New Project Proposal: SFF-TA-1016

Updated Scope Presented: December 01, 2023

New Project Proposal: SFF-TA-1016, updates to Rev 1.1

Sample changes to be made to the current 148 contact version plugs

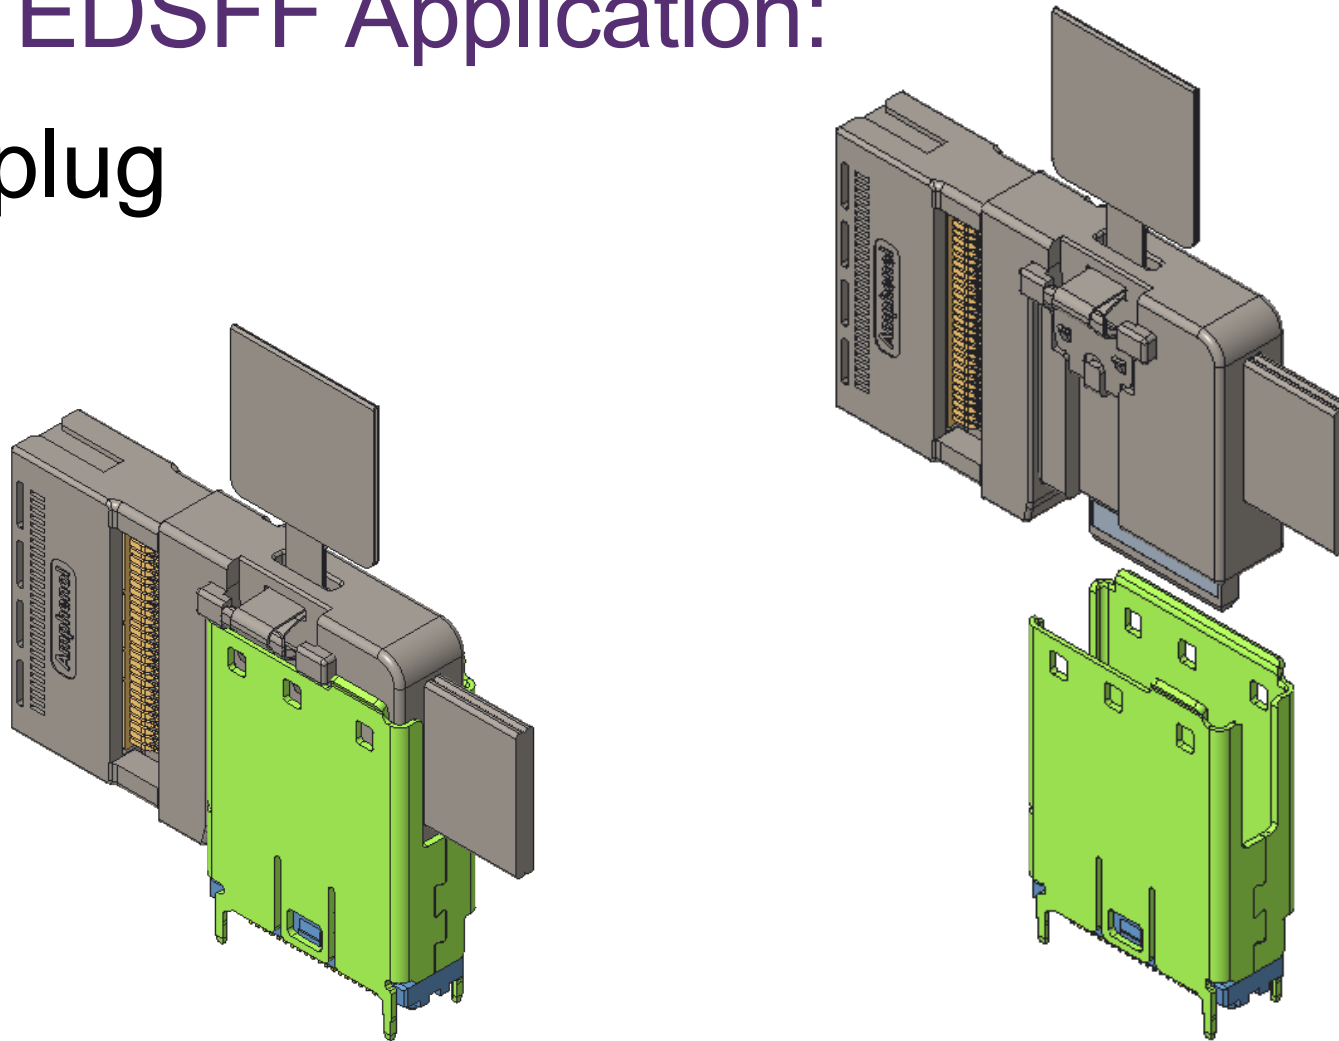
- Due to changes in PCIe add-in card keep out zones, two 74 contact x8 right angle connectors with mating no anti-skew side flange straight plugs will no longer fit along the short edge of a low-profile PCIe card. Alternatively, a 148 contact x16 right angle connector will still fit. However, the mating plugs with the anti-skew side flanges will violate the new keep out zones. So, a new no anti-skew side flange version of the plugs is needed.

- Add a no flange version of the 148 contact plugs, just like was done previously for the 74 contact version plugs.
 - Since we are adding a no anti-skew side flange version for yet another size plug, we might as well add a no anti-skew side flange version to all the remaining sizes in order to possibly prevent the need for future revisions of this specification. So, we will add a no anti-skew side flange version for the 38 contact plugs and 124 contact plugs as well, in case they are ever required.

Plug Connector: E1 1C plug

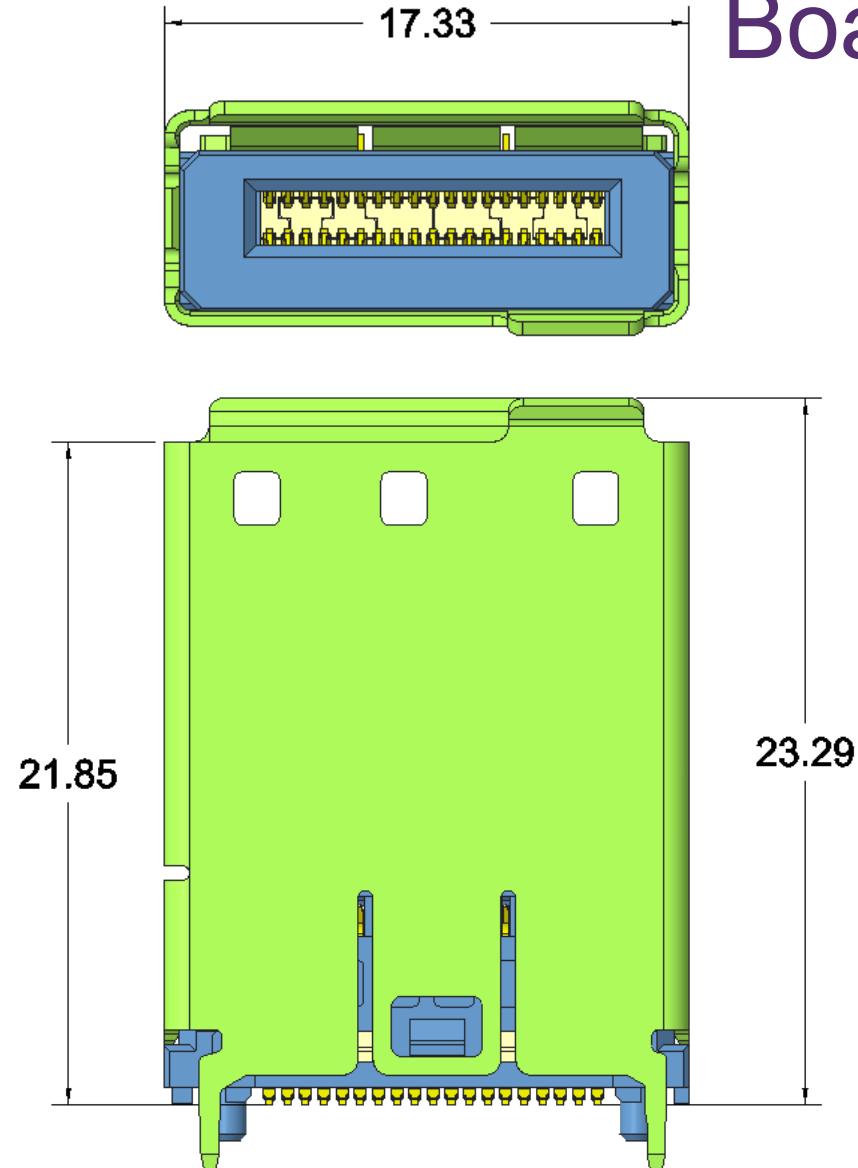
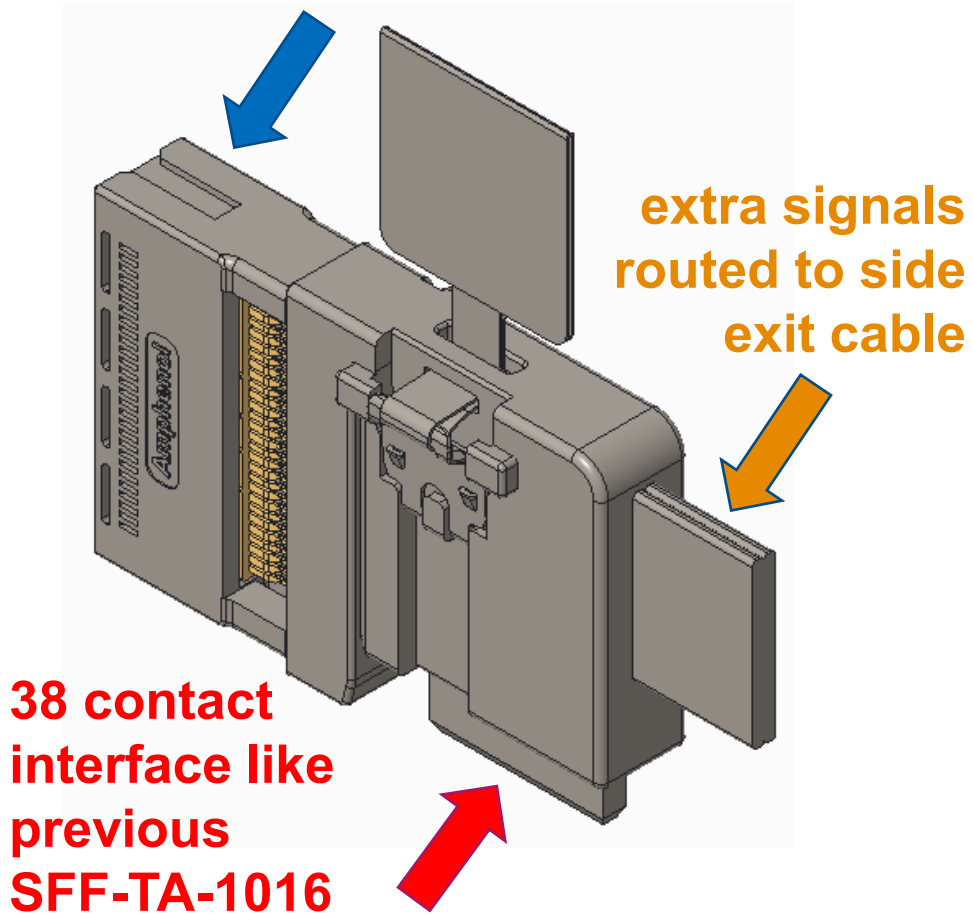
- Also, adding an EDSFF solution to the current configurations.
 - Add E1 1C plug & mating vertical receptacle connector
 - Add E3 1C plug, E3 2C plug, & mating vertical receptacle connector

New Hybrid EDSFF Application: E1 1C plug

Plug Connector:

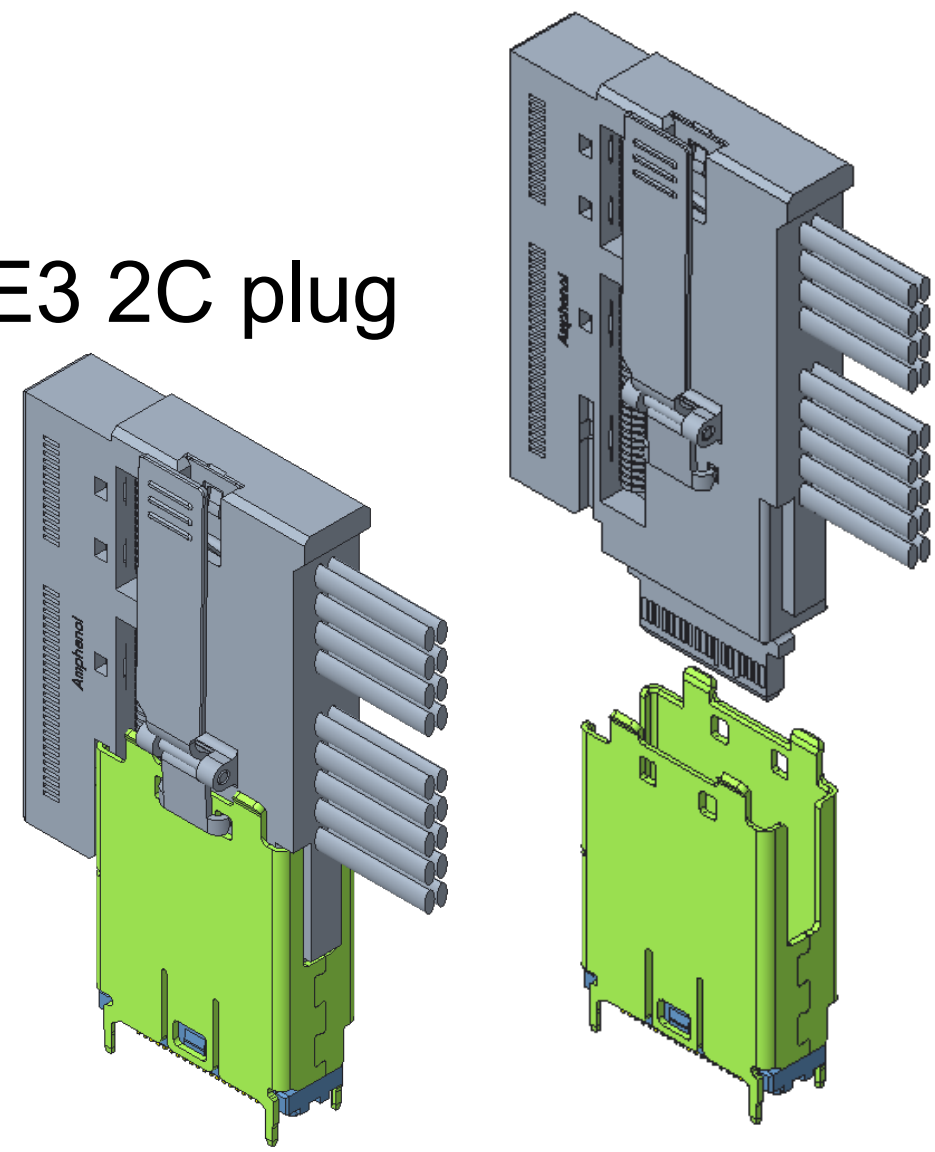
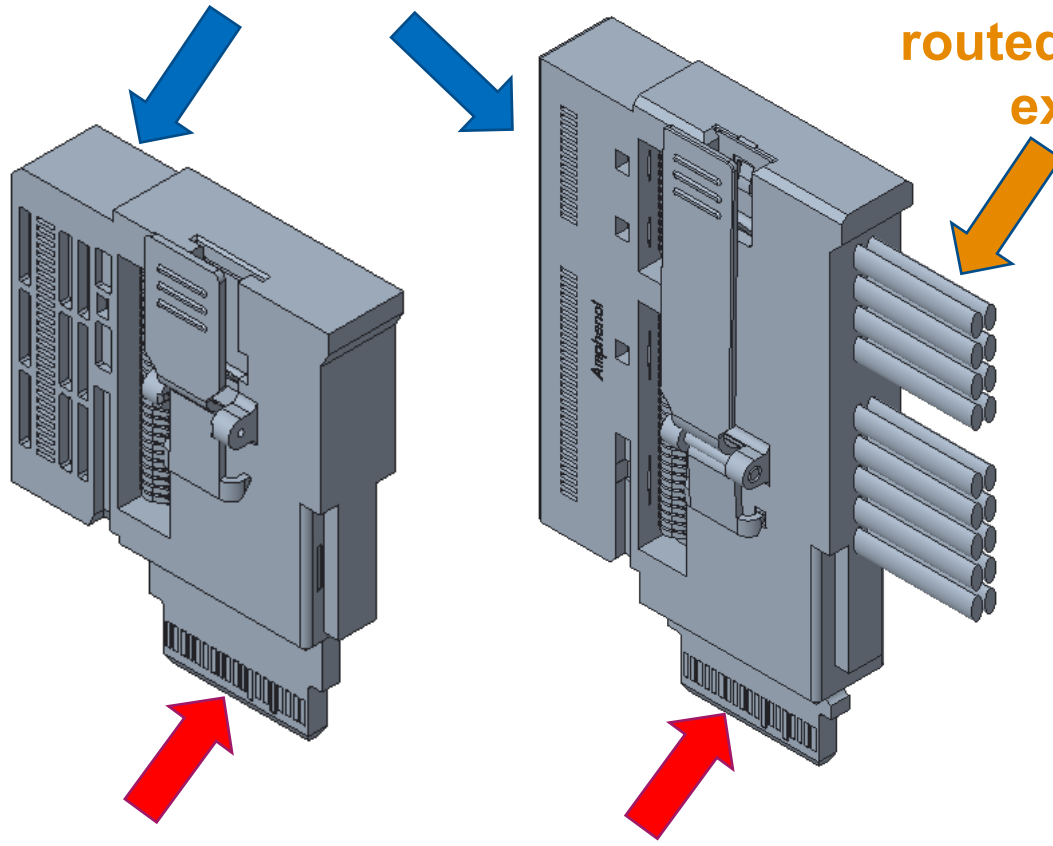
New Hybrid EDSFF Applications:
